NOEL PLACE SUBDIVISION, RE-SUBDIVISION OF

APPLICATION NUMBER 15 DATE July 5, 2012
 APPLICANT Noel Place Subdivision, Resubdivision of
 REQUEST Subdivision

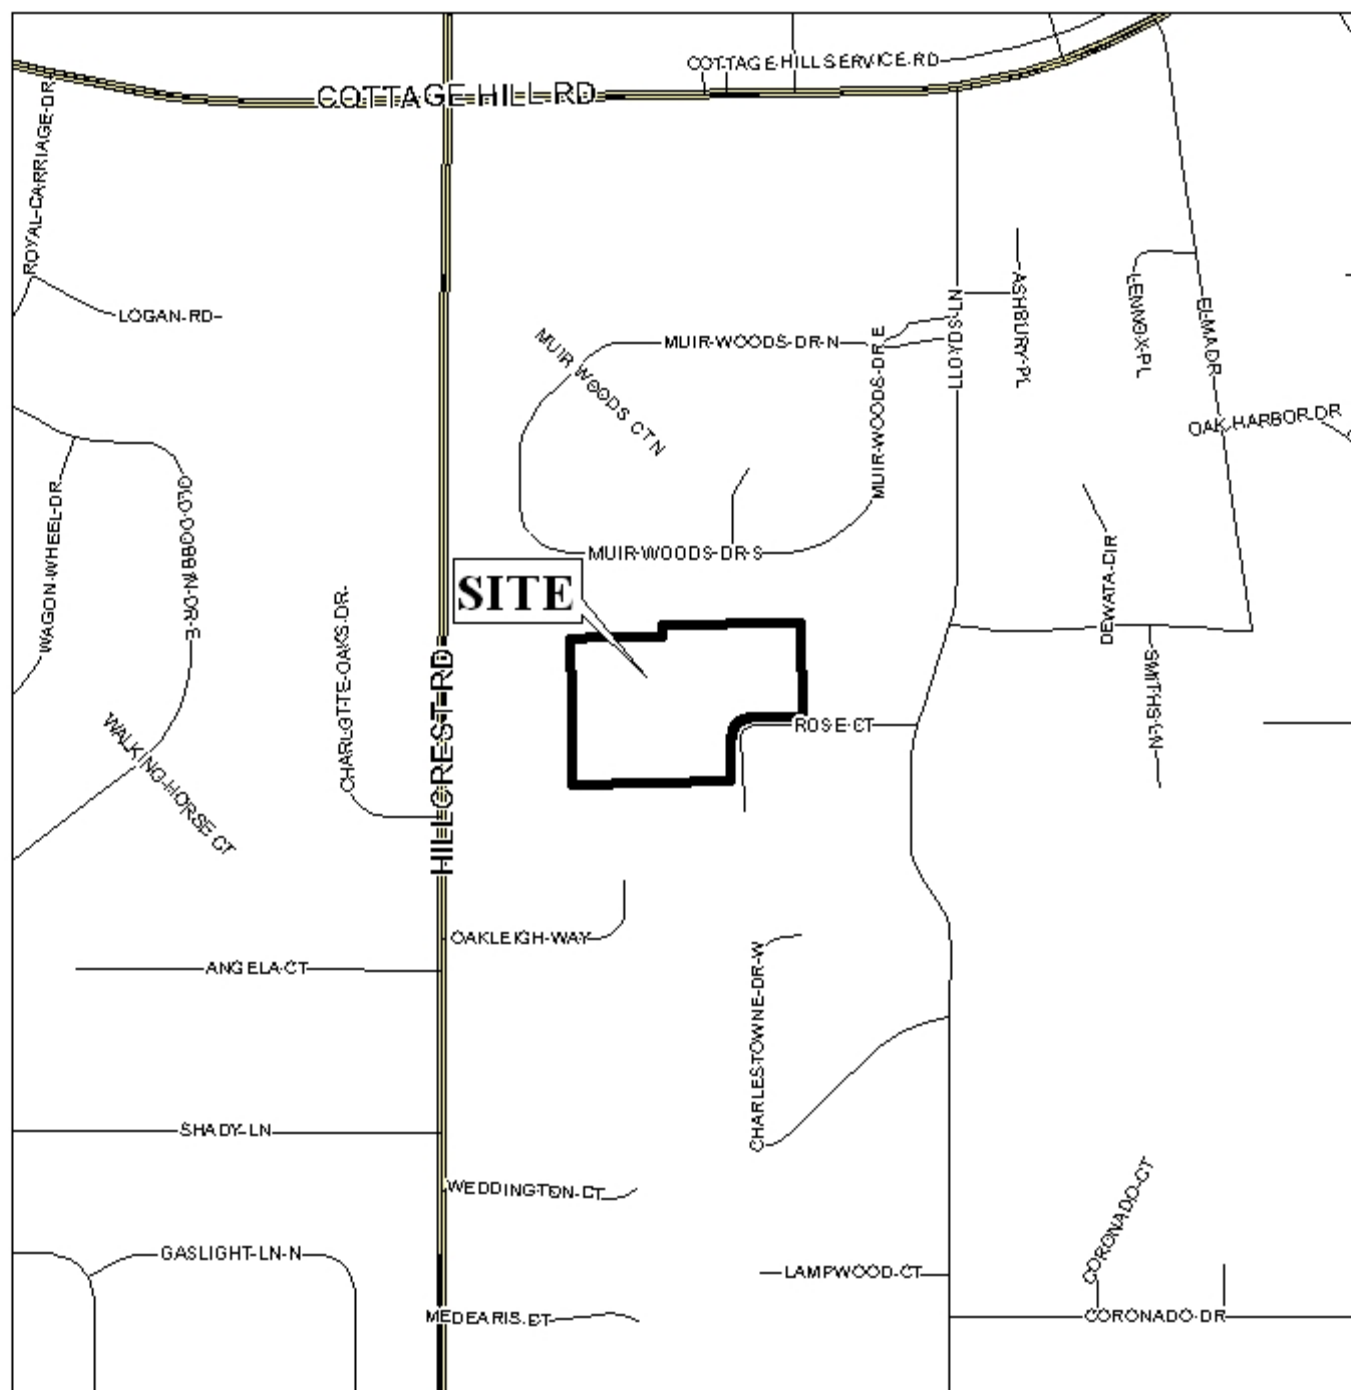
The site fronts Rose Court, a City-maintained gravel street. The plat does not show the right-of-way width, however, dedication was provided with the previous Subdivision application. The plat should be revised to provide a minimum and maximum right-of-way width.

Due to the fact that Rose Court is substandard in terms of width and surfacing, a condition was placed on the previous approval limiting each lot to one curb-cut. A house is currently under construction on proposed Lot B, and the site plan submitted with the application indicates a desire for two-curb cuts to allow a circular driveway. As the proposed increase in size of the lot will result in over 200 feet of frontage along Rose Court, an allowance for a second curb-cut may be warranted. Therefore, Lot A should be limited to one curb-cut and Lot B should be limited to

a maximum of two curb-cuts, with the size, design and location to be approved by Traffic Engineering and conform to AASHTO standards.

The plat illustrates the 25-foot minimum building setback, which should also be depicted and labeled on the final plat, if approved.

The plat meets the minimum standards of the Subdivision Regulations and is recommended for Tentative Approval, subject to the following conditions:

- 1) placement of a note on the final plat stating that there will be no future subdivision of either lot until Rose Court is improved to City Engineering standards;

- 2) the placement of a note on the final plat stating that Lot A is limited to one curb-cut, while Lot B is limited to two curb-cuts, with the size, location and design to be approved by Traffic Engineering;

- 3) depiction and labeling of the 25-foot building setback on the final plat;
- 4) depiction and labeling of the area of each lot in square feet on the final plat;
